TE Connectivity

Product Change Notification: P-26-030763

2-POS. SEALED 2.8MM USCAR CLEAN BODY FOR

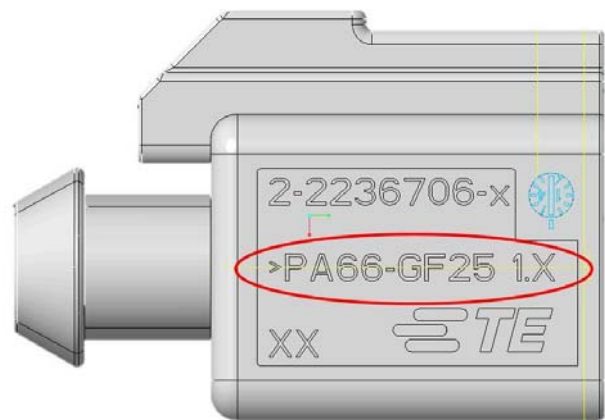
This product change notification (PCN) is to inform you about a material change from PA46-GF15 to PA66-GF25 impacting the PNs listed below in this PCN.

Before change

After Change

Product improvement.Change the material for the housing 2236697-1 from PA46-GF15 to PA66-GF25. Affected TCPNs:2-2236706-1 / 2-2236706-2 / 2-2236706-3 / 2-2236706-4 / 2236697-1 Affected Drawings: 2236697 / 2236706
